Subject: UTS and UTG dust cap design change (for plugs only)

UTS610DCG - UTS612DCG - UTS614DCG

UTG610DC - UTG612DC - UTG614DC - UTG616DC

UTG610DCG - UTG612DCG - UTG614DCG - UTG616DCG

UTG plug cap, sizes from 10 to 16:

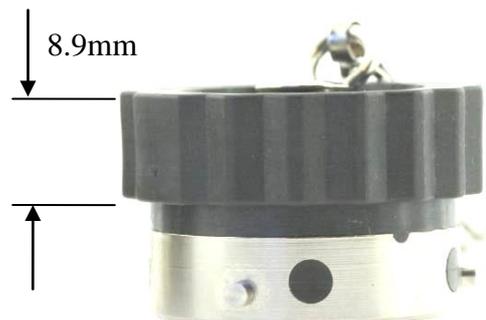
UTG & UTS cap flanges have been enlarged to ease the use in the field. Only sizes 10, 12, 14, 16 have been modified, other sizes already offered sufficient grip even when wearing gloves

Current design:

New design:

UTS plug cap, sizes from 10 to 14:

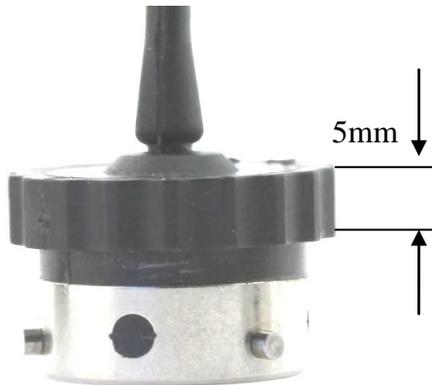
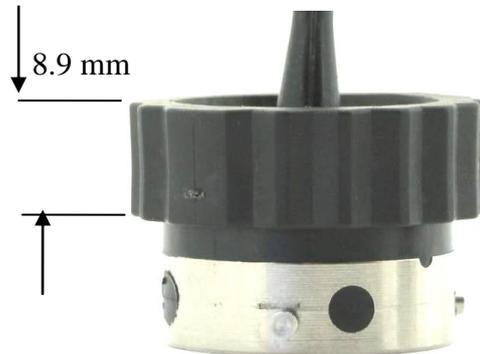
Current design:

New design:
